Access Compliance Report

Public Rights-of-Way

(Curb Ramps)

Intersection ID: 52928	Main Street: GRAY_OAK_LN	Cross Street: MAPLE_OAK_DR	Location: NW
ADA ID: D9B2202ED7D2	Ramp Type: Perp	Initial Pass/Fail: Fail	Overall Compliance: No
Severity Score: 8.75			
Codes/Mitigation Info/Possible Solution		Field Measurements/Component Compliance

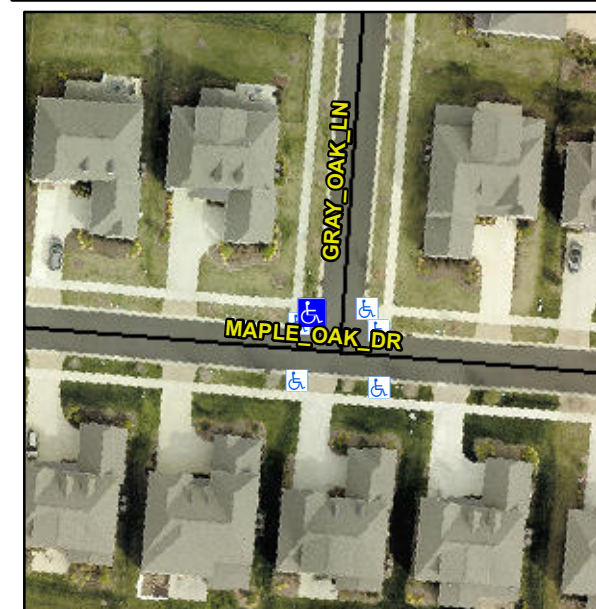
R304.5.1

Compliance	Description	Data	Compliance	Description	Data
N/A	Ramp Length (in)	36.5	Yes	Ramp Slope (%)	7.1
No	Ramp Width (in)	47.5	Yes	Ramp XSlope (%)	0.5
N/A	Flare Type LT	N/A	N/A	Flare Type RT	N/A
N/A	Flare Slope LT (%)	N/A	N/A	Flare Slope RT (%)	N/A
N/A	Flare Traversable LT?	N/A	N/A	Flare Traversable RT?	N/A
N/A	Landing Length (in)	N/A	N/A	DWS Provided?	N/A
N/A	Landing Width (in)	N/A	N/A	DWS Contrast?	N/A
N/A	Landing Slope (%)	N/A	N/A	DWS Length (in)	N/A
N/A	Landing X Slope (%)	N/A	N/A	DWS Full Width?	N/A
N/A	Landing Curb? (Y/N)	N/A	N/A	DWS Offset (in)	N/A
N/A	Shared Landing?	N/A			
N/A	Gutter Ponding?	N/A	N/A	Gutter Slope (%)	N/A
N/A	Gutter Lip Ht (in)	N/A	N/A	Gutter X Slope (%)	N/A
N/A	Painted X Walk1?	No	N/A	Painted X Walk2?	N/A
	X Walk 1 Direction	To E		X Walk 2 Direction	N/A
N/A	X Walk 1 Width (in)	N/A	N/A	X Walk 2 Width (in)	N/A
	X Walk 1 Slope (%)	2.0		X Walk 2 Slope (%)	N/A
	X Walk 1 X Slope (%)	0.7		X Walk 2 X Slope (%)	N/A

Remove & Replace Entire Ramp.
